Memorandum

TO: Columbia River Crossing Task Force
FROM: CRC Pedestrian and Bicycle Advisory Committee (PBAC)
SUBJECT: PBAC Recommendations for World Class Pedestrian and Bicycle Facilities

Purpose of this Memorandum

PBAC Proposed Pedestrian and Bicycle System for Replacement Bridge

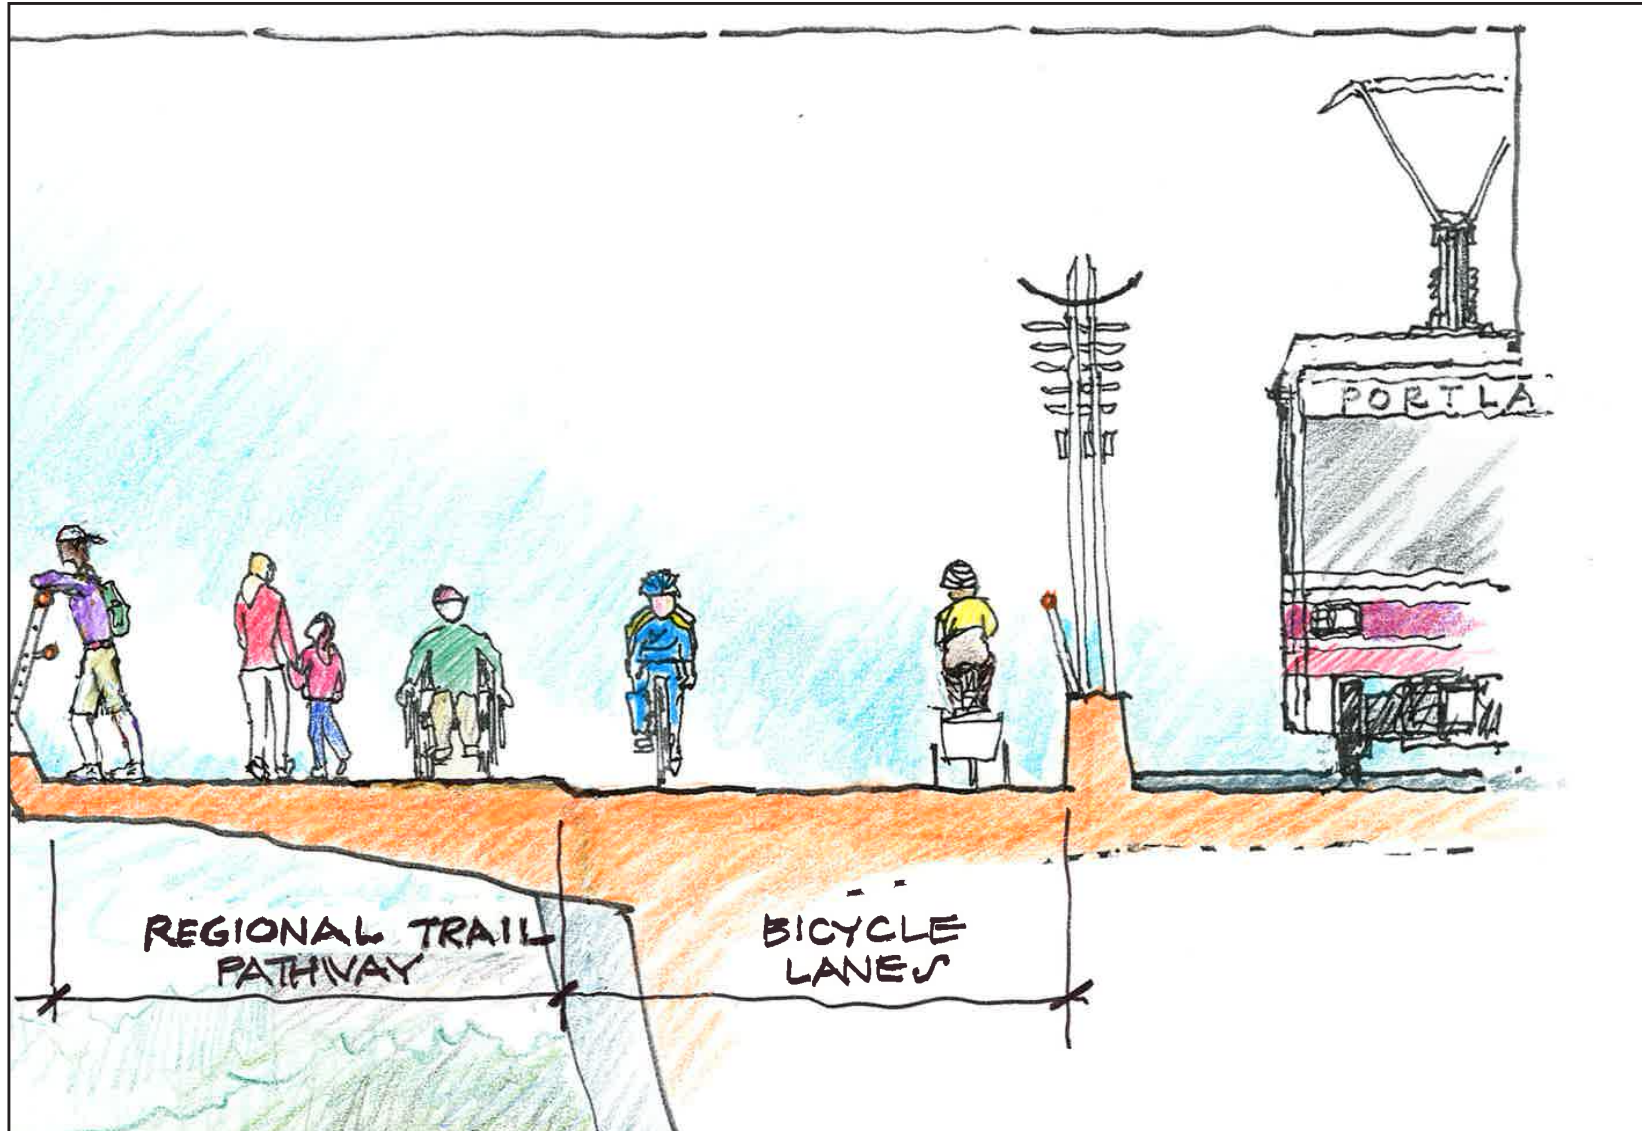
- The overall pathway on the western bridge (adjacent to the transit guideway) must provide separation between recreational users and higher speed bicycle users. To provide this separation, a 12-foot wide regional trail should be provided adjacent to, and to the west of, a pair of six-foot wide bicycle lanes (see attached rendering). These recommended widths are exclusive of potentially needed shy distances, i.e., free and clear of poles and other obstructions to enable safe pedestrian and bicycle movement (a summary of agency standards for multiuse paths, sidewalks and bike lanes is attached).

The regional trail would accommodate pedestrians, persons with disabilities, seniors, families with children, tourists, roller-skaters, and recreational bicycle riders. The adjacent bicycle lanes would be used by bicycle commuters and other faster-moving bicyclists. The regional trail would be at a slightly higher level than the bicycle lanes, but bicyclists in the bicycle lanes would be able to access the trail. Different paving treatments and/or patterns should differentiate the regional trail and the bicycle lanes.

- In addition to the combined regional trail and bicycle lanes on the western bridge, an eight-foot wide sidewalk should be provided on the eastern bridge (the bridge that would serve the northbound traffic lanes) across both the Columbia River and the North Portland Harbor. The sidewalk across the North Portland Harbor would touch down on Hayden Island and use surface street sidewalks to connect to the sidewalk across the Columbia River.
